Subject: [Non-DoD Source] EPA Comments on Destructive Testing Plan- Red Hill AOC SOW Section 5

Re: NAVFAC Destructive Testing Plan

3.1 Coupons for Testing for NDE Validation

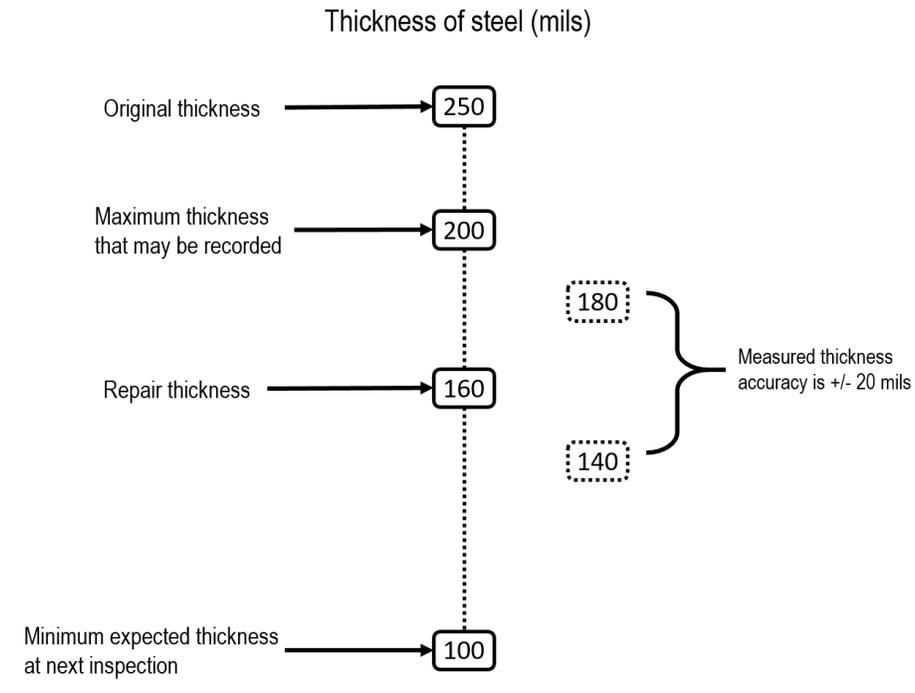
Comment 2. Although Section 3.1.1. describes the screening criteria, it is a little confusing. The discussion may be assisted by a diagram, similar to the one below. It would be beneficial for the Navy to confirm the accuracy of our diagram. The diagram below illustrates our understanding of screening criteria for those areas where the original steel thickness is 250 mils.

Navy Response to comment 2. While the above diagram is essentially accurate the Navy is concerned that, as depicted, the diagram could be interpreted to mean that the tolerance of +/- 20 mils only applies to the established threshold for repair, 160mils and that the “actual” threshold is 140mils. That would be an incorrect interpretation. The repair threshold is 160 mils with no tolerance assigned to it. The tolerance of +/- 20mils applies to the instruments used and would be applied to every measured reading. Therefore, the Navy recommends modifying the above diagram to remove the “180” and “140” and associated text and simply adding a footnote at the bottom of the diagram to indicate “The tolerance for all measurements of wall thickness is +/-20mils.” Further, it should be noted that a sufficient factor of safety has been incorporated in to the inspection process that even at 140mils the tank would still arrive at its next inspection cycle (20 years) before the minimum wall thickness of 100mils was reached due to corrosion. The Navy wishes to emphasize that the objective of the inspection phase of the clean, inspect and repair process (CIR) is NOT to characterize and record every single indication as revealed in the inspection process, but rather to identify those areas in need of repair so that sufficient steel plate could be applied to those sites to restore the wall thickness back to original levels or greater, thereby extending the service life beyond the next inspection cycle.

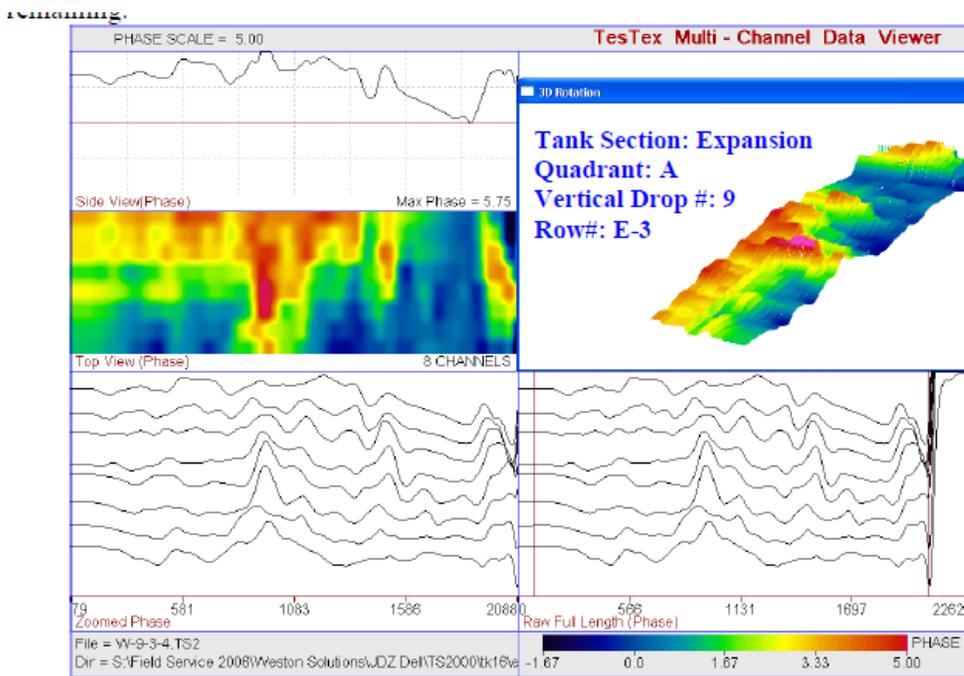
Comment 5. In the Destructive Testing Final Report, the Navy should plan to include the "3D" wave scan images produced by TesTex or EEI for the selected coupon locations, especially those with indications cited in the Master Table. EPA understands that some coupon locations may not have these images because they were not marked by TesTex or EEI, so wave scan images were never recorded and stored. However, for those coupon locations where wave scan images, partial or complete, were recorded, they should be included in the *Destructive Testing Final Report*. EPA acknowledges that these wave scan images were not available at the time of the *Destructive Testing Plan* or for the design of some of the Tank 14 clean and inspect repairs, resulting in the Navy producing the diagrams in Appendix B. See example image from a previous API Tank Report..

Flaw # 450, 451, 452, 453, & 454: The waveform above depicts an underside corrosion area exhibiting 0.160", 0.180", 0.150", 0.160", & 0.190" wall remaining.

Navy Response to comment 5. The wave scan images as depicted above were not saved or retained by the contractor and therefore do not exist for tank 14. The requirement to save these images was not included in the CIR contact of tank 14.

Diagram of Upper Dome with Agreed-Upon Coupon Location

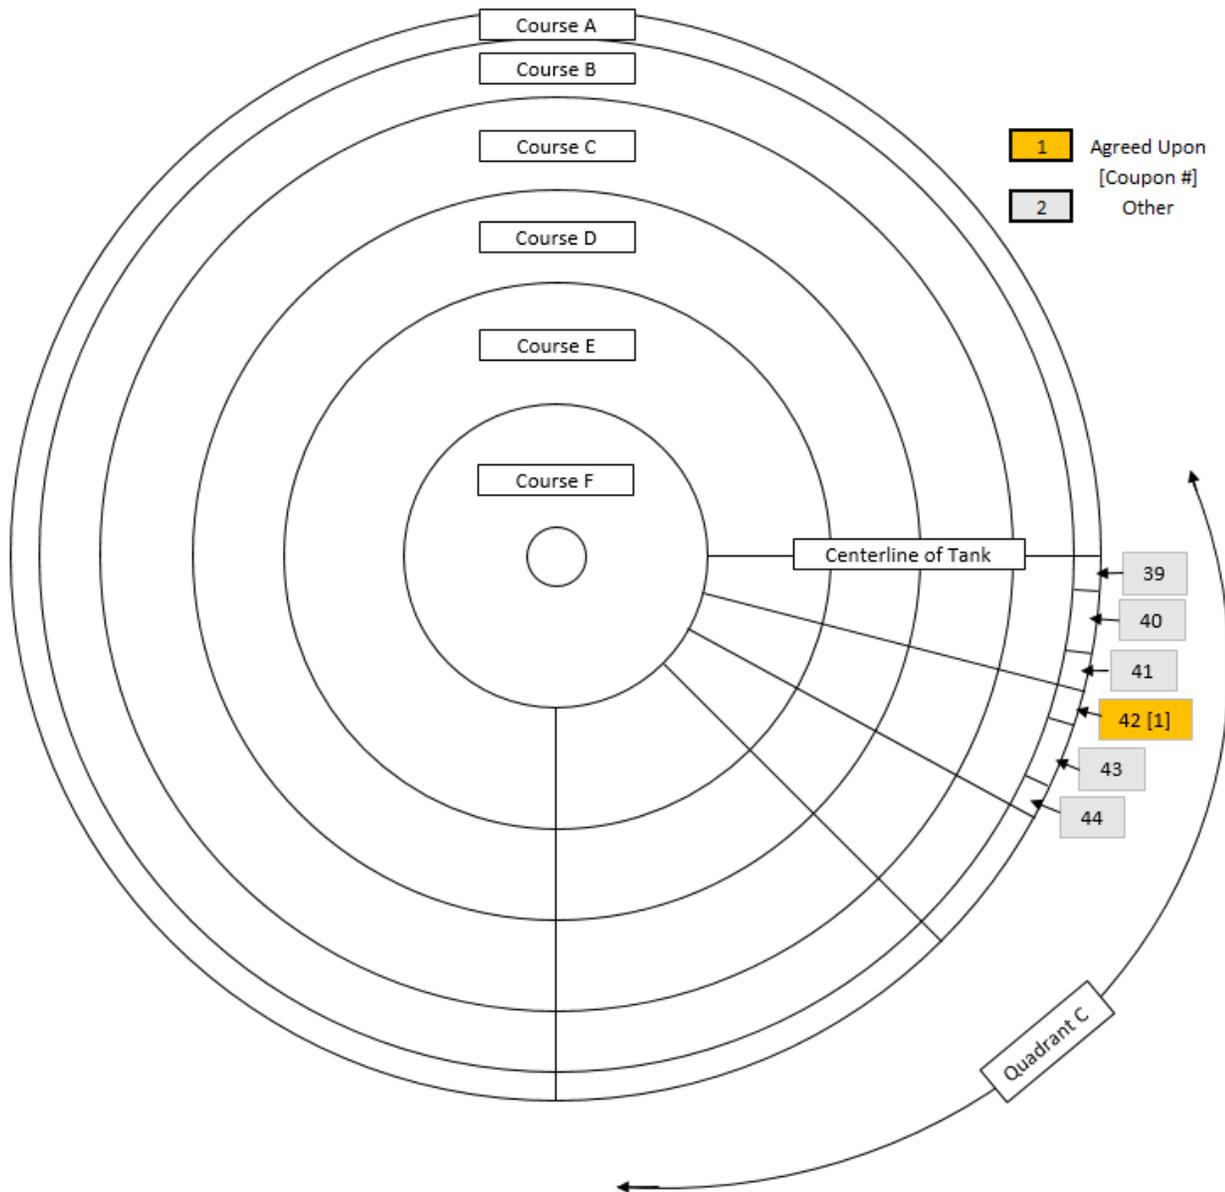
Comment 9. It would be helpful for the Navy to include a figure or diagram of the tank to show where coupons were selected in relation to tank area. See example map of tank below.

Navy Response to comment 9. See attached schematics.
